MIL-M-28787/305A(SH)
AMENDMENT 2
14 January 1992
SUPERSEDING
AMENDMENT 1
6 July 1983

MODULES, STANDARD ELECTRONIC

CONTROLLER, INTERRUPT, DIGITAL, KEY CODE ZJX

FIGURE 2. Operating temperature, component temperature, life test circuit and waveforms.

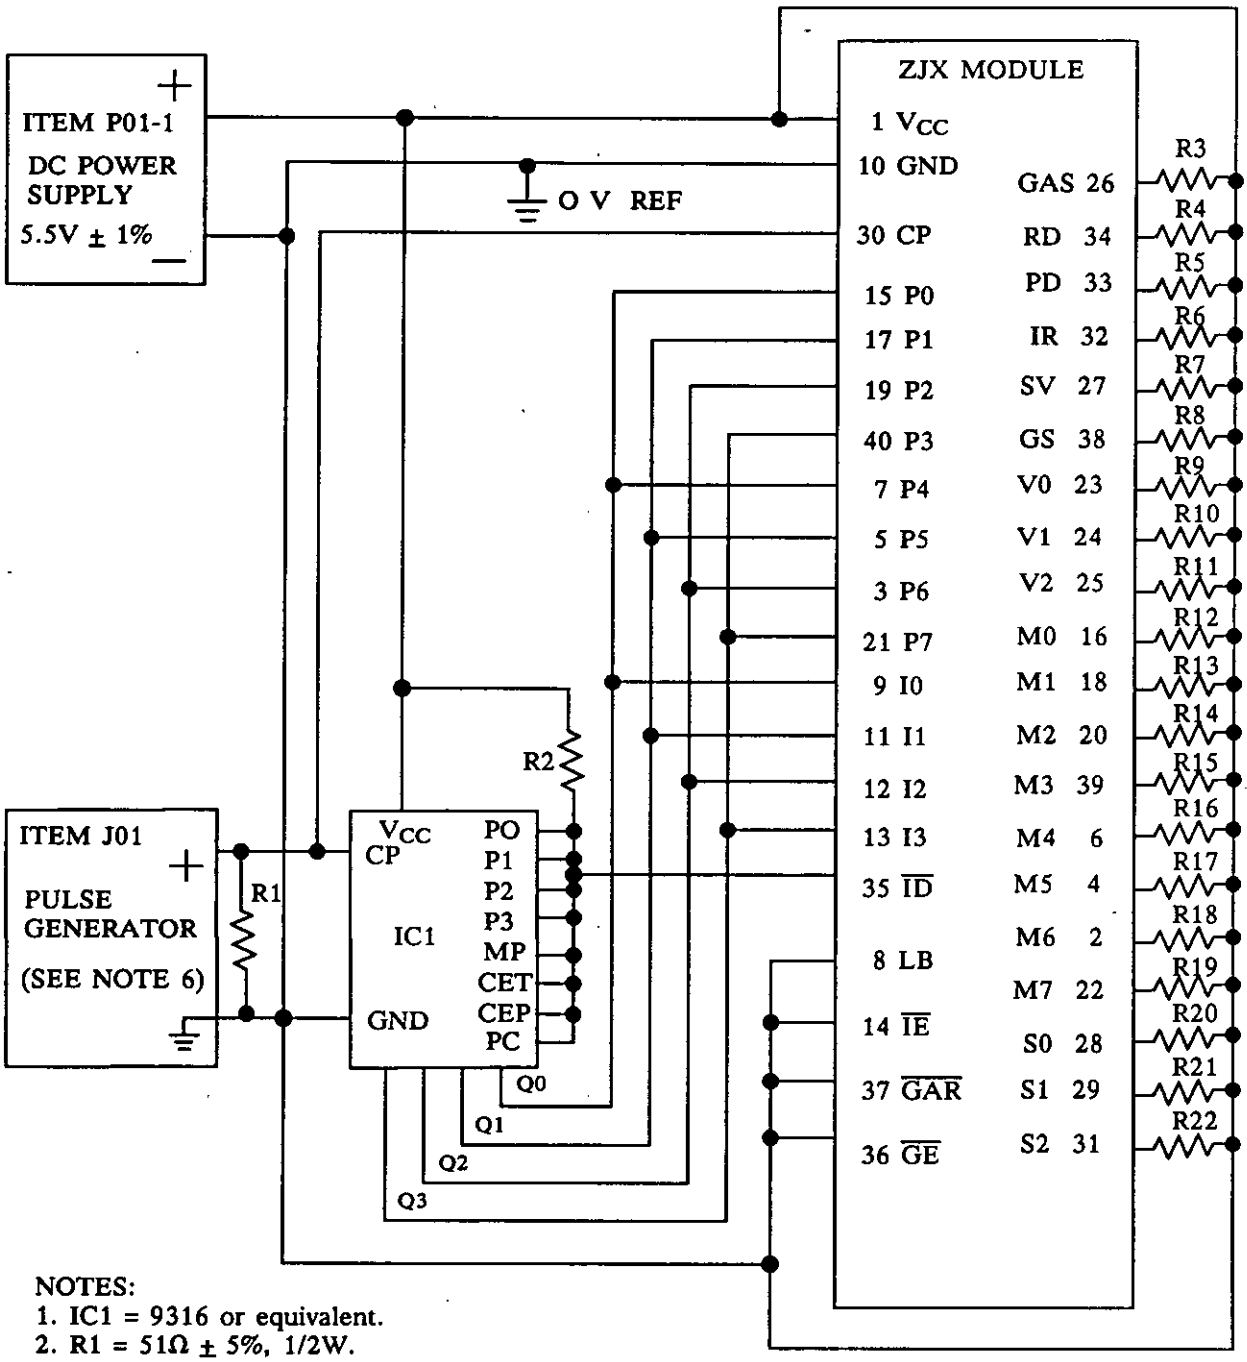
* FIGURE 2: Delete and substitute new figure 2 as printed on page 9 of this amendment.

NOTES:
1. IC1 = 9316 or equivalent.
2. R1 = 51Ω ± 5%, 1/2W.
3. R2, R12-R22 = 1.2kΩ ± 5%, 1/4W.
4. R3-R11 = 420Ω ± 5%, 1/4W.

FIGURE 24. Output crosstalk, high and low level, test circuit for tables XX and XXI.

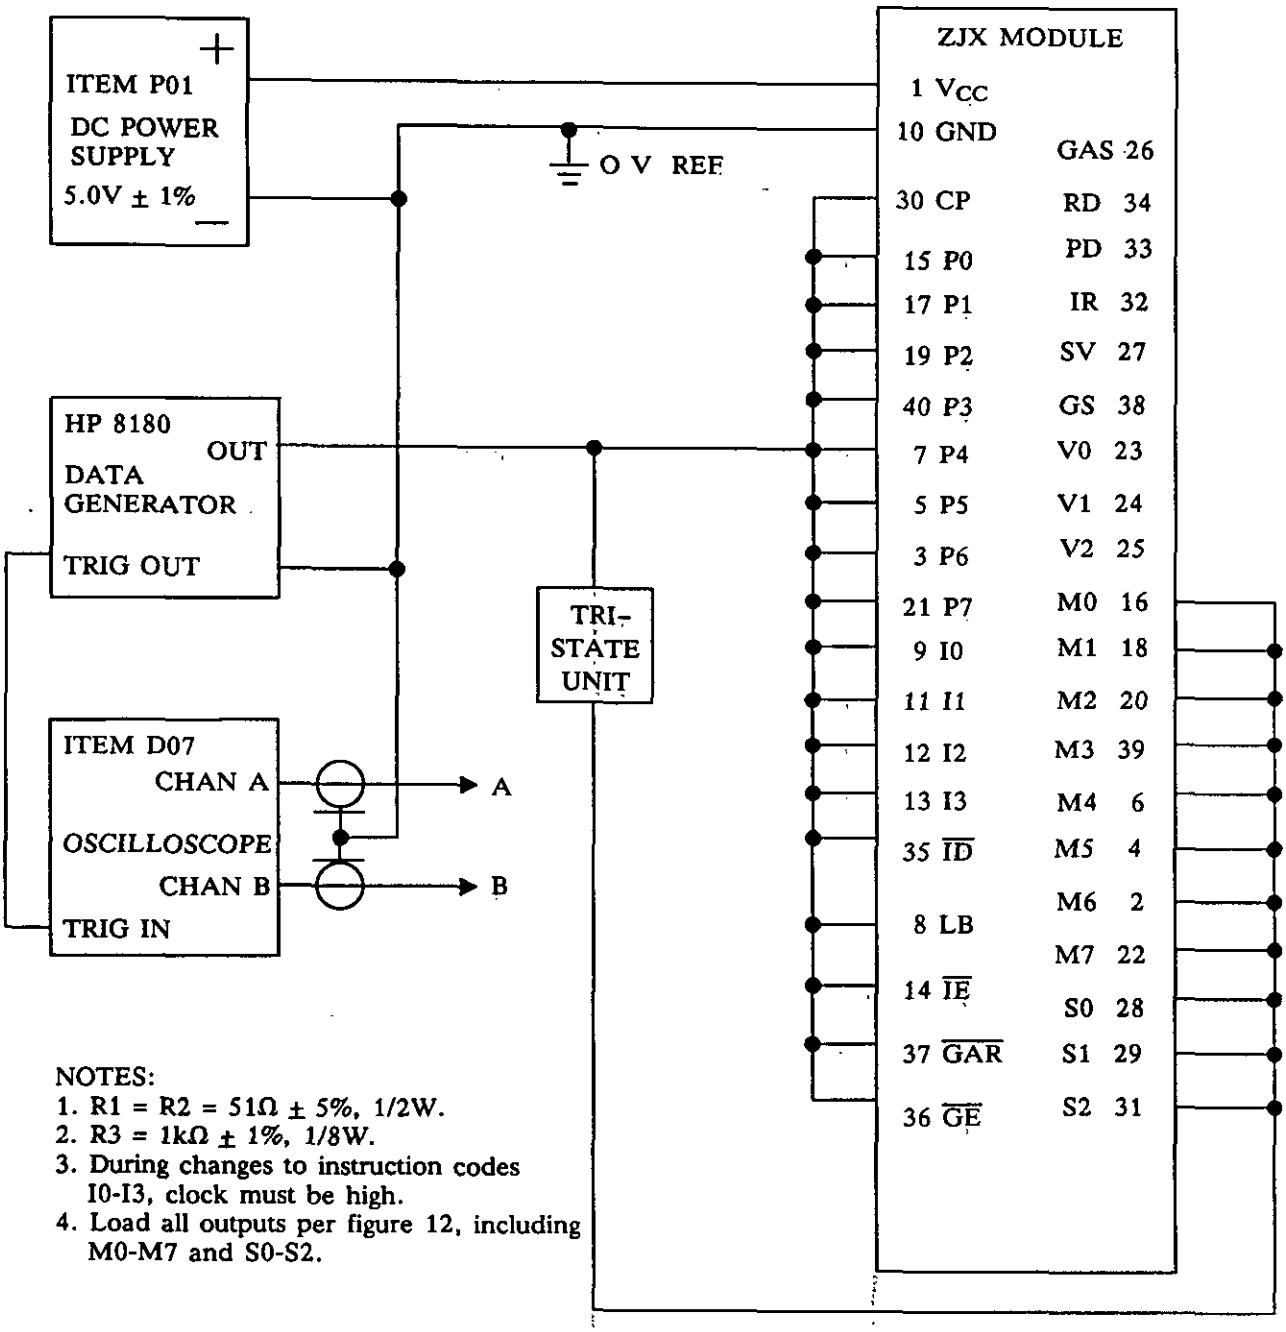
* FIGURE 24: Delete and substitute new figure 24 as printed on page 12 of this amendment.

NOTES:
1. R1 = R2 = 51Ω ± 5%, 1/2W.
2. R3 = 1kΩ ± 1%, 1/8W.
3. During changes to instruction codes I0-I3, clock must be high.
4. Load all outputs per figure 12, including M0-M7 and S0-S2.
